## Advice Note

**Project:** DA/655/2019 | 134-142 Parramatta Road, 26-38 Good Street, 59-61 Cowper Street Granville

**Subject:** Response to Council RFIs

**Document Reference:** SY191237-SEME-1

### **4.13.1 Loss of ceiling insulation from ceiling penetrations**

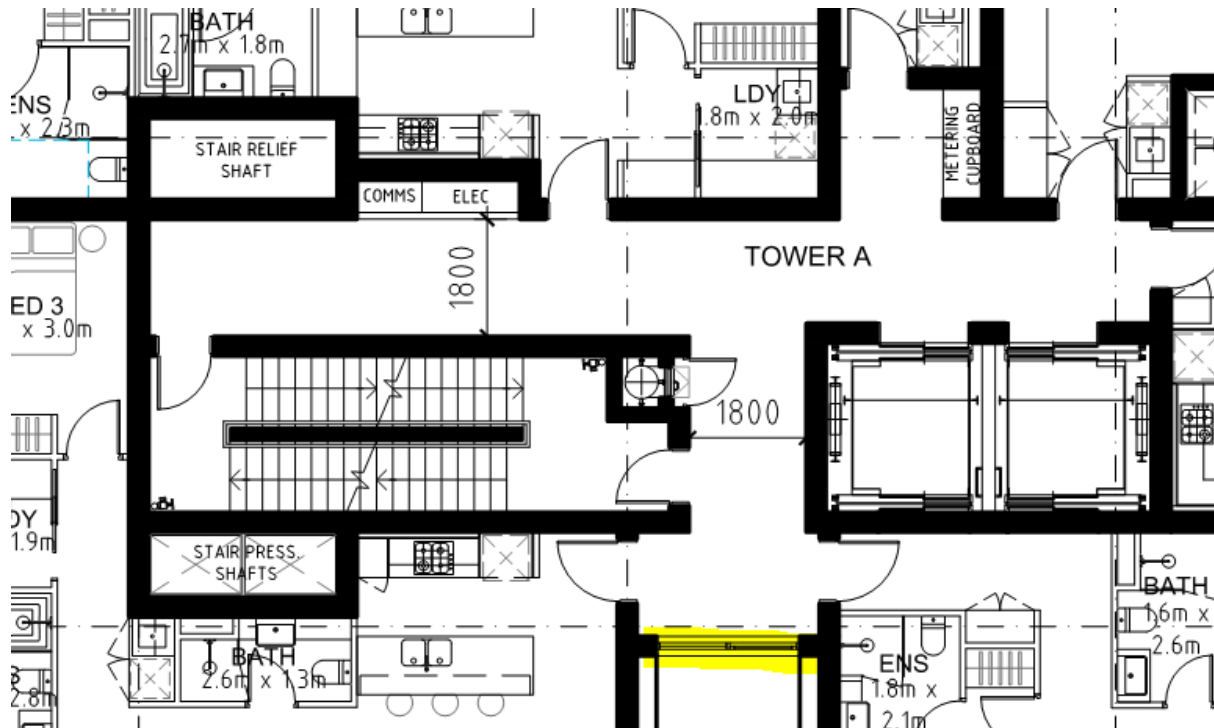
**3. Auditor has not allowed for downlights as per default values from BASIX TCP.**

As stated in the BASIX Thermal Comfort Protocol 4.13.1, if lighting plan is not available, assessor may rate the dwelling with no ceiling penetrations from luminaires. Furthermore, provision of thermally sealed downlights or no downlights is included in the BASIX notes.

If the lighting plan is not available after written requests to the client have been made, Accredited Assessors may rate the dwelling with no ceiling penetrations from luminaires. Alternatively, Accredited Assessors may model the penetrations based on the following defaults:

AAO has not raised any issues regarding this approach.

### **4.13.1 Loss of ceiling insulation from ceiling penetrations**

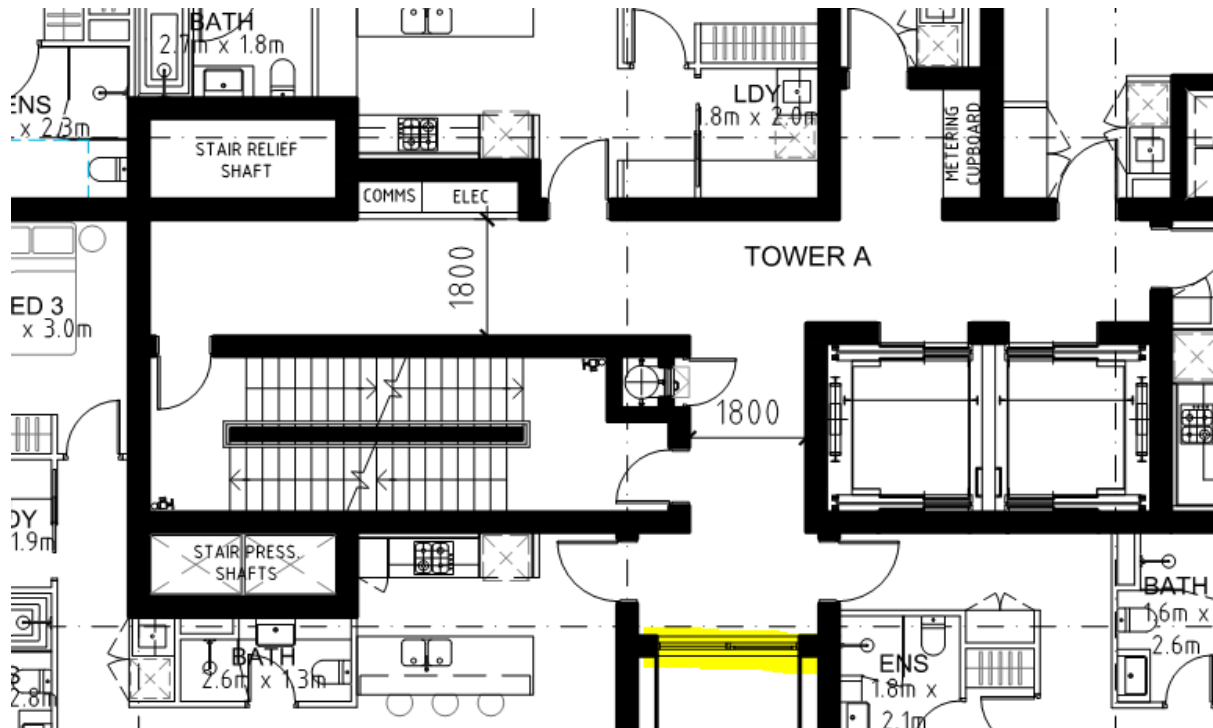
**2. Auditor has not allowed for downlights as per default values from BASIX TCP.**

As stated in the BASIX Thermal Comfort Protocol 4.13.1, if lighting plan is not available, assessor may rate the dwelling with no ceiling penetrations from luminaires.

If the lighting plan is not available after written requests to the client have been made, Accredited Assessors may rate the dwelling with no ceiling penetrations from luminaires. Alternatively, Accredited Assessors may model the penetrations based on the following defaults:

- Halogen downlights with the default dimensions and clearance from the software, in each zone where the downlights are likely to be installed based on the professional judgement of Accredited Assessors, and
- At a rate of 4 ventilated recessed downlights per 10 square metres of ceiling area in each zone being considered by Accredited Assessors. For zones between 5 and 10 square metres allow 2 recessed downlights and 1 recessed downlight for zones less than 5 square metres. For example a combined living/kitchen area of 15 square metres would have 6 ventilated recessed downlights, and a living/dining of 30 square metres would have 12.

The certificate must be revised when the lighting plan becomes available and if the number of ceiling penetrations from recessed luminaires being modelled (none or the defaults listed above) is lower than the number in the lighting plan. Using the defaults above may reduce the impacts of simulated heating and cooling loads after revisions.

ABSA has confirmed this is an acceptable approach as long as the final report will be revised when lighting plans become available. ABSA's correspondence is provided at the appendix.
